Project: FY26 Door Upgrades

300 Level Egress Doors and 100 Level Stadium Club Entry Doors

Addendum No. 01 - October 15, 2025

Section 357

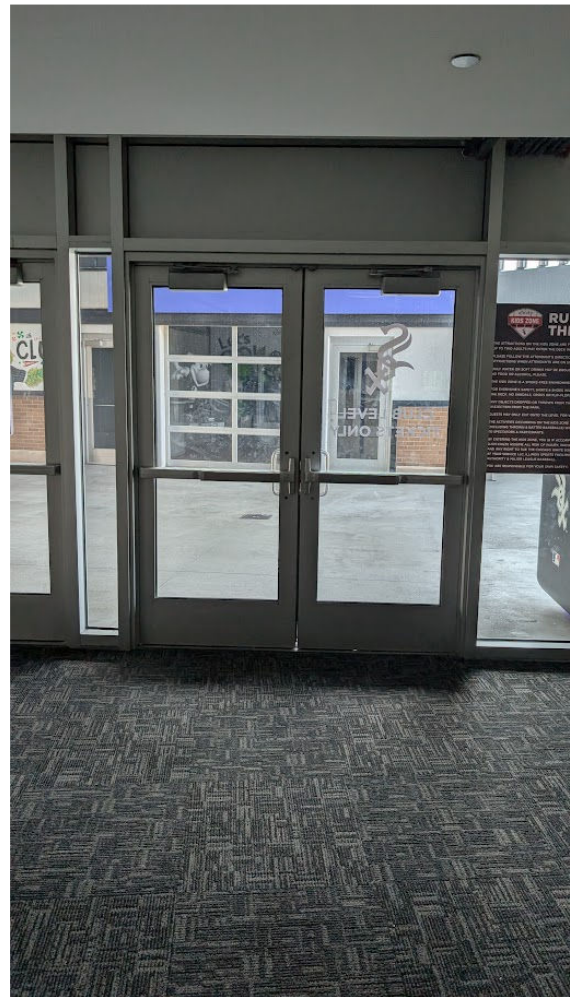
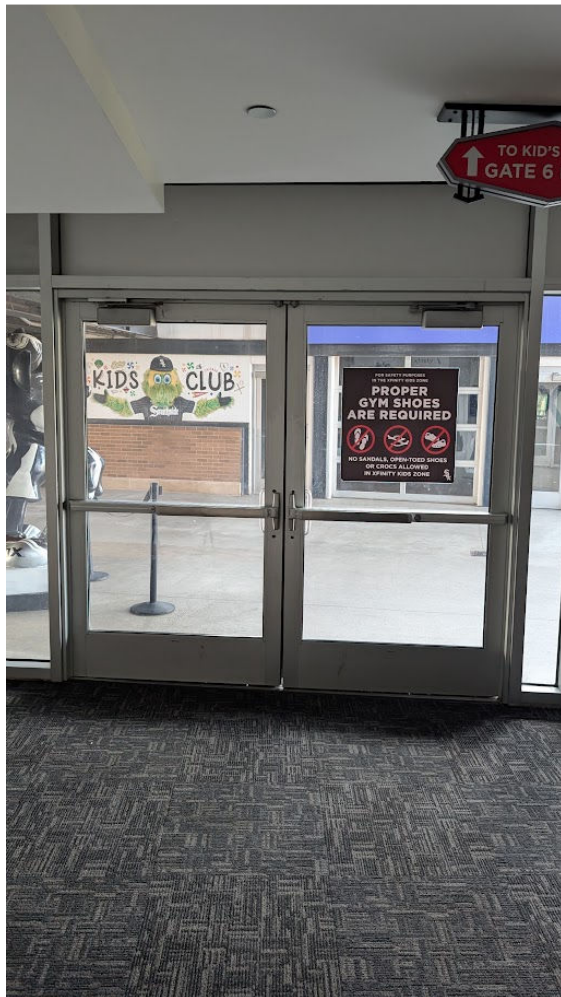
Adjust doors to ensure smooth and reliable operation including closers, push bars, and drop rods.

Provide and install new weatherstripping as required to provide weathertight enclosure.

ADD ALTERNATE: Provide and install Von Duprin 3347A Concealed Exit Device OR EQUAL

Section 338

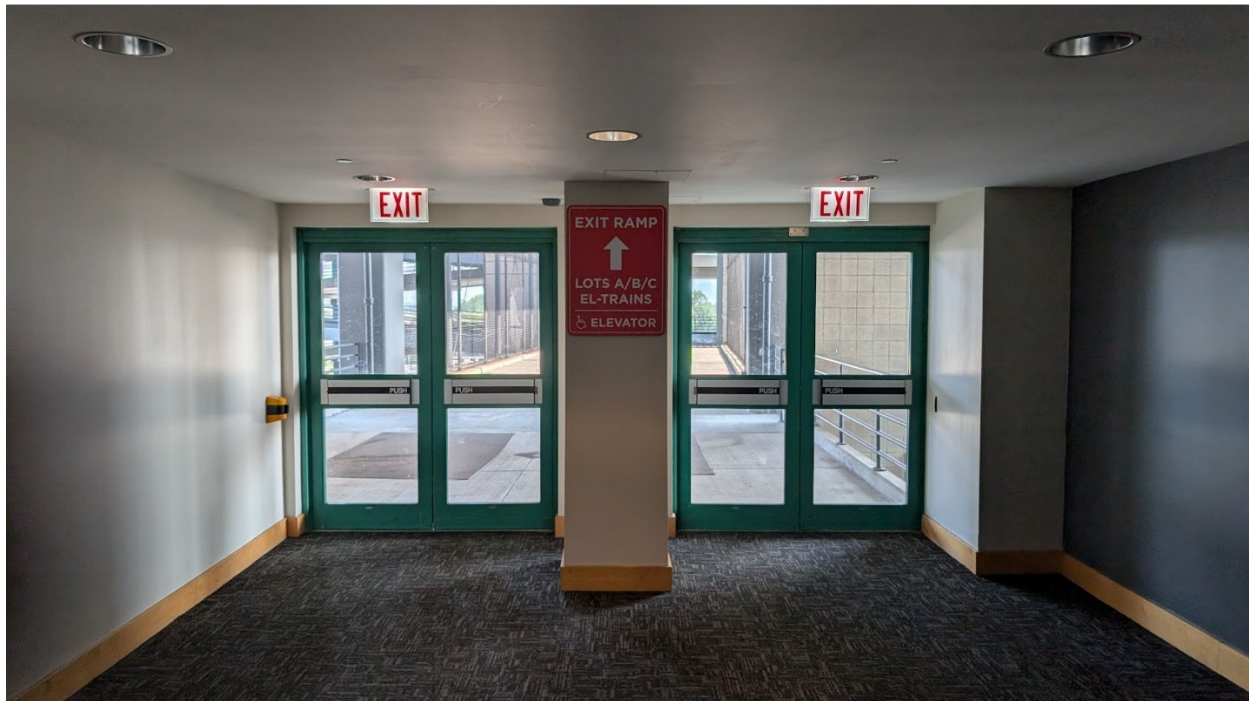
- 1.1. 1- $\frac{3}{4}$ " medium stile thermal doors with min. 10" bottom rail
- 1.2. Architectural Class 1 clear anodized finish
- 1.3. 1" clear insulated tempered glass
- 1.4. (3) butt hinges (US 26D)
- 1.5. ADA complaint threshold NGP 613HD or equal
- 1.6. ~~Paneline Concealed Rod Exit Device with standard pull CTC offset pull handle~~ **Von Duprin 3347A OR EQUAL**
- 1.7. Rim cylinder with Schlage LFIC Cylinder for interchangeable core (final cores to be provided by CWS)
- 1.8. LCN 4040XP – 3049CNS Hold Open HCUSH closer OR EQUAL
- 1.9. Floor Stop FS4555 Kickstand
